**ZONING AMENDMENT,  
PLANNED UNIT DEVELOPMENT &  
SUBDIVISION STAFF REPORT**

**Date: December 4, 2008**

Russell School Lofts Subdivision

304 South Broad Street  
(Southwest corner of South Broad Street and Augusta  
Street, extending to the North side of Savannah Street  
130'± West of South Broad Street).

# SITE PLAN

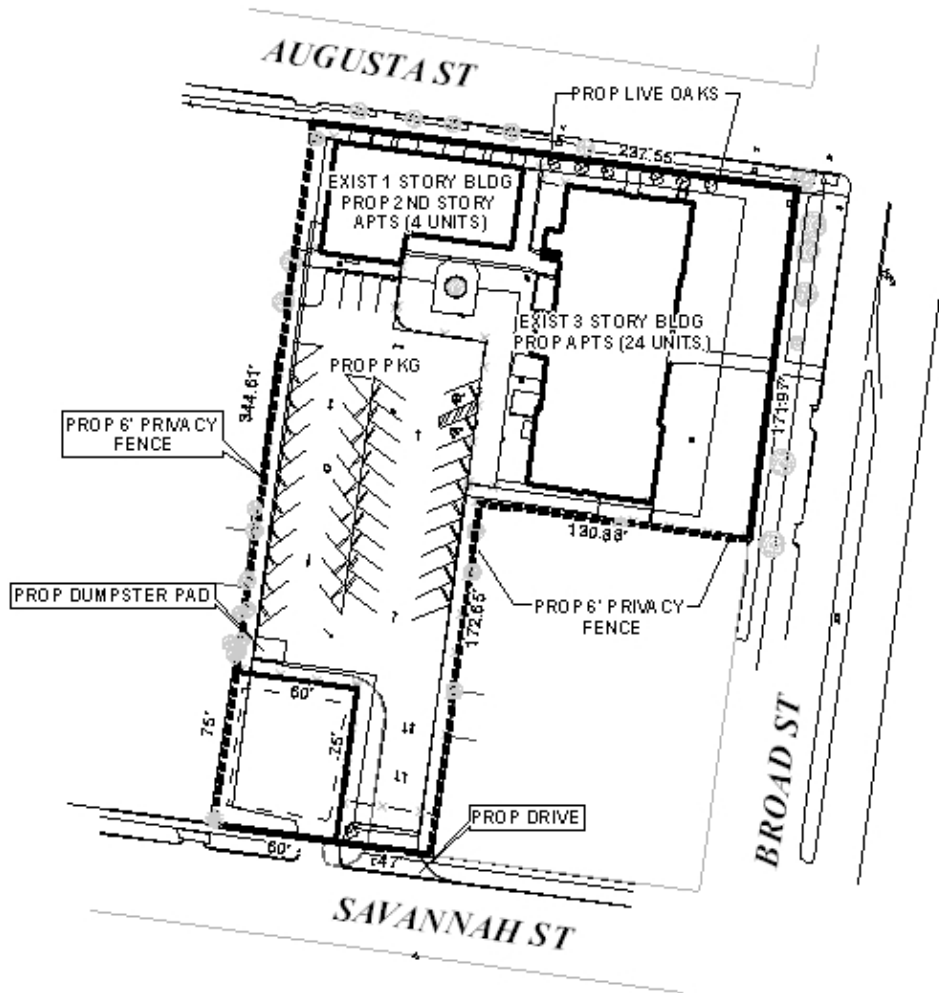
Because of the scope of the condominium conversion and the size of the parking area for the development, a 10 foot protection buffer as described in Section 64-4.D.1 should be required. The applicant is depicting the dumpster within the 10 foot buffer area that is recommended to be required. The dumpster should be depicted outside of the recommended buffer area and likewise should be depicted as being appropriately screened.

The site plan depicts a privacy fence and gate across the parking area access. The applicant does not depict an adequate queuing area of 3 spaces. Section 64-4.F.2.a defines a queuing space as being a minimum of 9 feet wide by 17 feet long. In keeping with the intent of the ordinance, 3 queuing spaces would be considered adequate as that is the minimum number of queuing spaces required for drive-thru lanes. As such, the privacy fence gate should be relocated on the plat to provide at least 51 feet from the **property line**. Because 51 feet is the bare minimum amount of queuing space, the applicant should be required to construct the entry gate so that the gate open inward toward the parking area and not outward toward the right-of-way as opening outward would reduce the amount of queuing space. The opening radius size and direction of the gate as well as the queuing spaces should be noted on the site plan.

The site plan depicts the entry drive leading into a designated parking space. Paint striping or curb and gutter with landscaping should be provided to direct entry traffic into the parking access aisle rather than into the first parking space, and the site plan should reflect this requirement.

Lastly, the landscaping plan does not reflect any heritage tree plantings along Broad Street. The applicants appear to be requesting credits for existing live oak canopy coverage. As such, the area of the live oak canopies should be depicted on the landscape plan so credits can be calculated.

- 1) Revision of the site plan to indicate a protection buffer compliant with Section 64-4.D.1 of the Zoning Ordinance between all property to be zoned R-3 and all property zoned R-1;

- 2) Revision of the site plan to depict the dumpster outside of the protection buffer and to depict appropriate screening of the dumpster;
- 3) Revision of the site plan to depict at least three (3) queuing spaces, as defined in Section 64-4.F.2.a of the Zoning Ordinance, leading up to the entry gate;

- 4) Revision of the site plan to depict the opening radius and direction of opening for the entry gate;
- 5) Revision of the site plan to reflect paint striping or curb and gutter with landscaping in the area where the entry drive leads into the parking area;

- 6) Depiction of the canopy area of live oaks located on the right-of-way that are to be used for canopy coverage credits;
- 7) Full compliance with Engineering Comments: *Must comply with all storm water and flood control ordinances. Any work performed in the right of way will require a right of way permit. Must provide detention for any impervious area added since 1984 in excess of 4,000 square feet. Since the property is located within the X-Shaded Flood Zone, show Minimum FFE on plans and plat;* and

## SUBDIVISION AND ZONING DETAIL

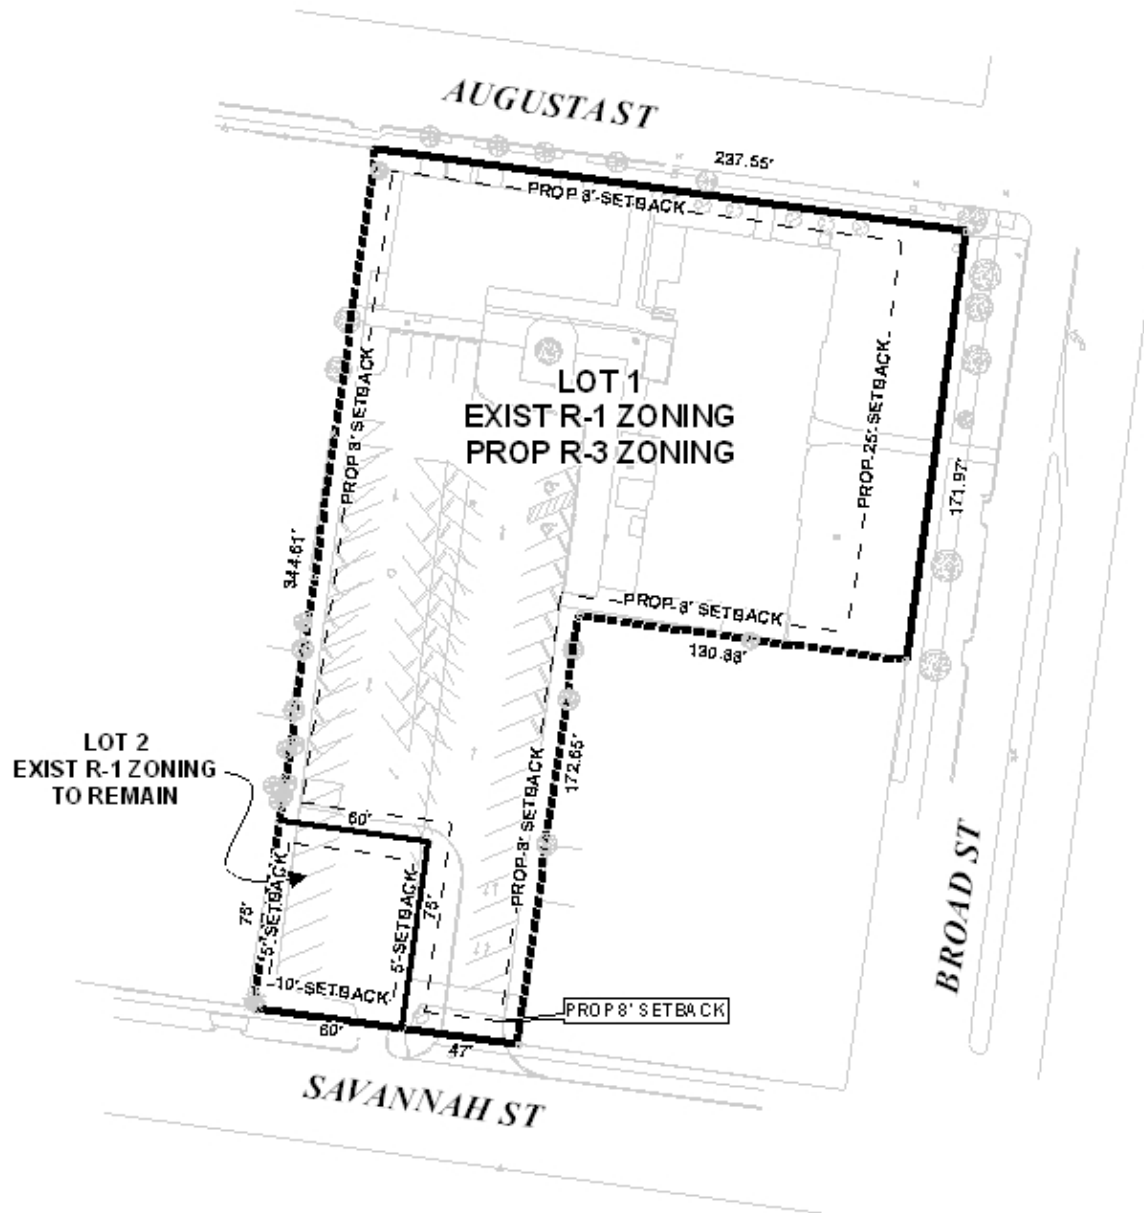
to the south. The major street plan stipulates a 100 foot right-of-way for Broad Street in this area; a 100 foot right-of-way already exists, therefore no additional dedication should be required. Augusta Street and Savannah Street are minor streets which are provided with curb and gutter. Section V.B.14 of the Subdivision Regulations stipulates that a 50 foot right-of-way be provided; an adequate 50 foot right-of-way currently exists for both streets, therefore, no additional dedication should be required. It should be noted that the curb radius does not currently meet standards at the intersection of Broad Street and Augusta Street, as such, dedication sufficient to meet the curb radii standards of Section V.B.16 of the Subdivision Regulations should be required.

Due to Broad Street's designation as a major street, access management is a concern. The current layout of the existing buildings also limits the site's access. As such, the proposed Lot 1 should be limited to one curb cut to Savannah Street with the size, location, and design to be approved by Traffic Engineering and conform to AASHTO standards. The proposed Lot 2 should be limited to one curb cut to Savannah Street with the size, location, and design to be approved by Traffic Engineering and conform to AASHTO standards.

The proposed Lot 1 meets the requirements of the Subdivision Regulations for public right-of-way frontage and minimum lot size. The proposed Lot 2 illustrates the required amount of public right-of-way frontage, however it does not meet the minimum size standards as outlined in Section V.D.2 of the Subdivision Regulations. These regulations require a minimum lot size of 7,200 square feet. The proposed lot is illustrated at 4,500 square feet, which is smaller than the regulations specify. This site is located in the Oakleigh Garden Historic District, in an area of the city that far predates both the Zoning Ordinance and the Subdivision Regulations, and there are lots in the immediate vicinity that are similar in size as the proposed Lot 2. As such, a waiver of Section V.D.2 of the Subdivision regulations regarding minimum lot size may be appropriate.

- 1) Revision of the plat to reflect compliance with Section V.B.16 of the Subdivision Regulations regarding curb radii at Broad Street and Augusta Street;

- 2) Placement of a note on the final plat stating that Lot 1 is limited to one curb cut to Savannah Street, with the size, location, and design of all curb cuts to be approved by City of Mobile Traffic Engineering and meet AASHTO standards;

- 3) Placement of a note on the final plat stating that Lot 2 is limited to one curb cut to Savannah Street, with the size, location, and design to be approved by City of Mobile Traffic Engineering and meet AASHTO standards;

- 6) Labeling of all lots with the size of each lot in square feet or provision of a table on the plat with the same information;
- 7) Submittal of the final PUD showing all recommended revisions to the Planning Section of the Urban Development Department;
